Information request

This information request is issued by the administering authority under section 140 of the Environmental Protection Act 1994 (Qld) to request further information needed to assess an application for a PRCP schedule.

Our reference: P-EA-100114292

The application reference number is: C-PRCP-100776070

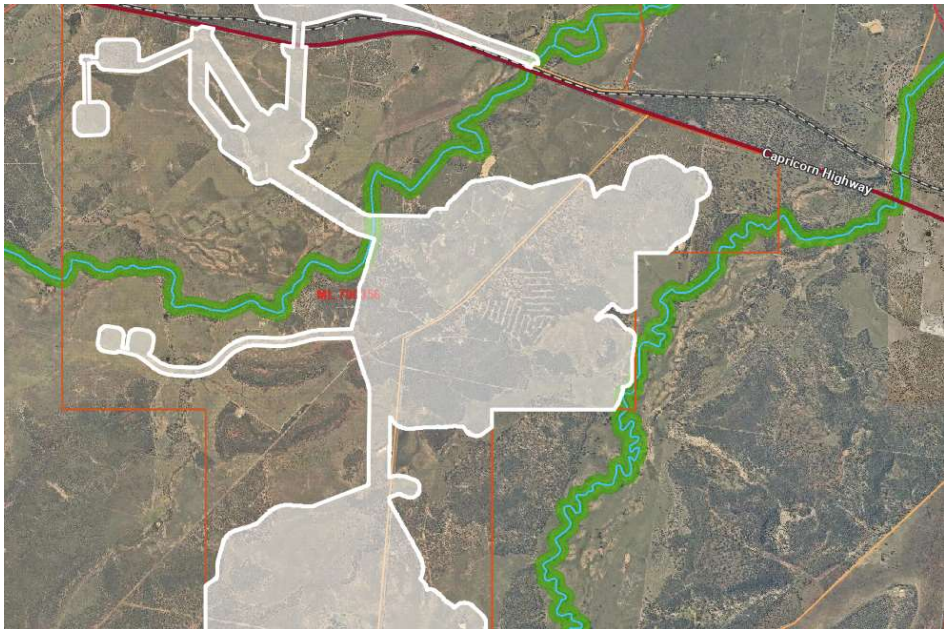
2.	3.1.4.1 Surface water quality	Contaminants of concern (CoC) Table 9 in section 3.1.4.1 shows the surface water monitoring data (2019-2024), however there is no explanation for the parameters chosen to be reported. Only mean data is provided, and the appendices do not include all data collected. The water quality parameters should align with an analysis of the potential contaminants of concern (CoC). The parameters reported in for the PRCP plan are not clearly linked with any analysis of the CoC for the site. Overall the PRCP contains limited analysis of the CoC for the site, and further detail is necessary to demonstrate a meaningful linkage between the monitoring parameters and the contaminants potentially generated by mining. The PRCP guideline section 3.1 requires EA holder to provide baseline information with respect to site hydrology and fluvial networks. In accordance with the PRCP guideline section 3.6.1, the Rehabilitation Planning Part must include a description of the following: • a description of the contaminants that pose a risk to environmental values of the receiving environment.	1. Update the PRC Plan to include: • Analysis of contaminants of concern at the site. This should consider the relevant activities on site, and the characterisation of waste material. • Summary statistics of baseline water quality (Table 9) should include median, 80th and 95th percentiles, in addition to mean.

source, pathway and fate of contaminants that have the potential to impact environmental values. CoC should be consistent between surface water and groundwater. This information is important as it helps to determine the water quality limits, as well as the suitability of monitoring locations to demonstrate the stability and non-polluting state of the final rehabilitated landform. It should be noted that water quality objectives for post-closure are often different to operational water quality limits in the EA. It should be noted that Condition F3 of the EA requires a study of the source of contaminants to be completed for the Water Management Plan, which is due within one month of the grant of ML. This study should have already been completed, and should be provided to support the PRC Plan.	Include all surface water data collected to date as an appendix to the PRC Plan. 2. Provide the Water Management Plan developed in accordance with Condition F3 of the EA including the study of source contaminants.

Figure 52: A Void post mining salinity

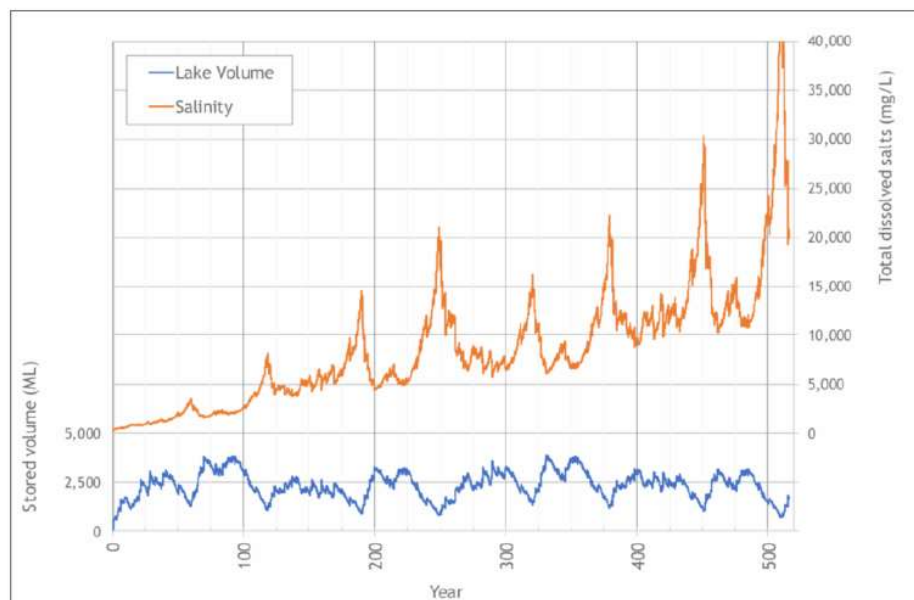
13.	3.3.3 Proposed post-mining land uses 3.5.6.7 Final void study	Final voids PMLU Magnetic South have made a commitment to rehabilitate the final voids to achieve a PMLU of fauna habitat. While this may be achievable in the first 100 years, there is risk associated with the increasing salinity levels and their ability to support an aquatic ecosystem over the long-term. Figure 52 (section 3.5.6.7) shows that the salinity levels are predicted to continue to increase over 500 years for Mine A void. A PMLU must be able to achieve a stable condition, which in accordance with s111A of the EP Act: Land is in a stable condition if – a) The land is safe and structurally stable, and b) There is no environmental harm being caused by anything on or in the land, and c) The land can sustain a PMLU. The requirement for land to sustain a PMLU, and prevent environmental harm, does not end after 100 years. The PRC plan must demonstrate how the final voids will achieve fauna habitat, particularly the aquatic ecosystem component, to reach a stable condition post-closure. The PRCP Schedule must include appropriate SMART criteria that will achieve and sustain the PMLU. As per section 3.2 of the PRCP guideline, it is the applicant's responsibility to provide sufficient evidence and justification regarding any proposed PMLU.	1. Update the PRCP Plan to explain how the final voids will reach a stable condition, and continue to sustain an aquatic ecosystem long-term. 2. Ensure criteria that meet the SMART principle are included in the schedule that will deliver a stable PMLU of fauna habitat.

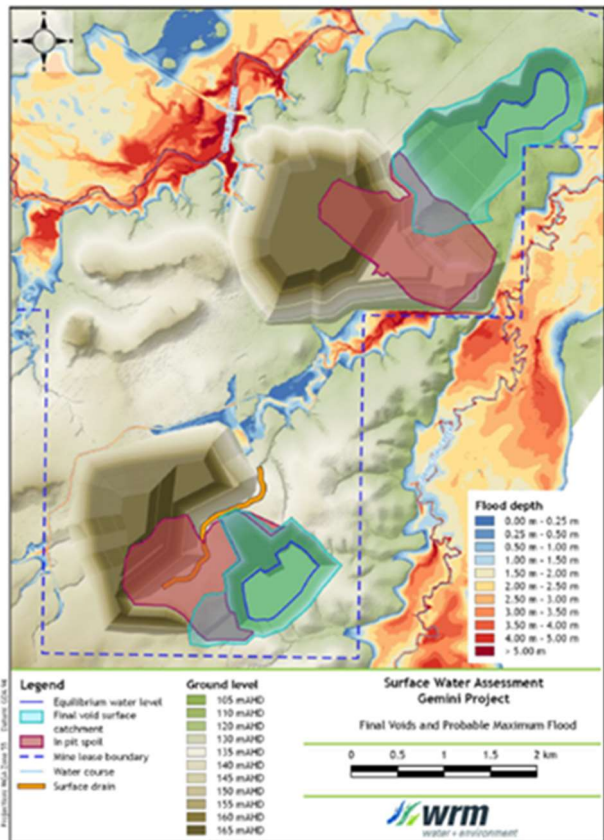
28.	3.7.1 Monitoring methodology	Monitoring of GDEs This section does not include any monitoring of potential GDEs identified on site, or within the drawdown impact area of the project site. It is acknowledged that one confirmed GDE will be impacted directly by mining activities. However, the other confirmed GDE on Charlevue Creek, and the potential GDE associated with the HES wetland (as discussed in item 28 above), should be monitored for drawdown impacts during closure activities.	1. Update the PRC Plan to address GDE monitoring.
29.	3.7.1 Monitoring methodology	Monitoring sites	1. Update the PRC Plan to provide all the required information on proposed analogue monitoring

The PRC plan does not provide sufficient detail on the analogue/ reference sites for rehabilitation monitoring. Parts of section 3.7.1 cattle grazing is referred to as the only pre-mining land use, however other sections concede that native vegetation communities are also in the landscape pre-mining. Section 3.7.1 should clearly nominate distinct analogue reference sites for each of cattle grazing and native vegetation communities. The section should make clear how many analogue sites will be developed for each pre-mining use, and provide their locations and a description of the current conditions, supplemented with photographs where possible. Section 3.7.1 on page 153 states 'periodic monitoring of reference sites will provide an understanding of the pre-mining landscape, assisting in the future planning and refinement of rehabilitation strategies' which indicates that the reference sites should already be defined and all information should be included in this PRC plan. It is important for the department to understand the condition of the analogue monitoring sites to ensure that monitoring rehabilitation against these sites will indicate achievement of the desired PMLU.	sites. This should include, at a minimum: - the number and location of sites, - the proposed frequency of monitoring, - The pre-mining land use that the PMLU will be compared to - Photographs of the current condition of the analogue sites.
